SLO.DOA.002	Service Bulletin	Document-No.: SB-100-004
	Service Bulletin No.: SB-100-004	Issue: A.03
	Disconnection of all second LiFePO4 batteries	Page: 1 of 4

Disconnection of all second LiFePO4 batteries

- Category:** MANDATORY
- Subject:** Disconnection of all second LiFePO4 batteries
- Affected Aircraft s.n.:** All Sinus, Virus, Virus SW and ALPHA trainer aircraft that have two LiFePO4 batteries installed
- Time of Compliance:** Immediate.
- Reason:** To prevent any chance of a short circuit occurring and causing potentially dangerous current surges
- Actions:** Disconnect the second LiFePO4 battery and, if desired, remove it
- Documents:** N/A
- Required Material:** N/A
- Mass and Balance:** Must be redetermined only if the second battery is removed from the aircraft
- Required Records:** Compliance with this Service Bulletin must be recorded in the aircraft's documentation and confirmed by submitting the provided and completed Service Bulletin Compliance Sheet (Attachment) to Pipistrel.

Figure 1

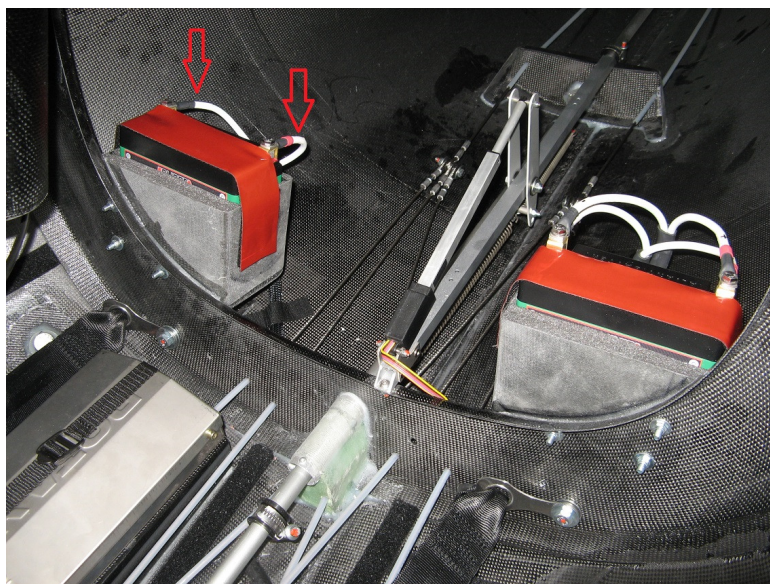
Disconnecting the second LiFePO4 battery: dual aft battery configuration

In those aircraft that have both batteries located in the luggage compartment, the positive and negative cables need to be disconnected from the second battery (see Figure 1). Once disconnected, they must be fastened to something with tape or plastic ties, to prevent them from shifting and/or moving around during aircraft operation. More importantly, the cable terminals, as well as the battery terminals, must be thoroughly insulated/protected to prevent them from touching components/installations nearby. After the cable is disconnected, the second battery can either be left where it is or removed. Only the later requires redetermining the aircraft's weight and balance.
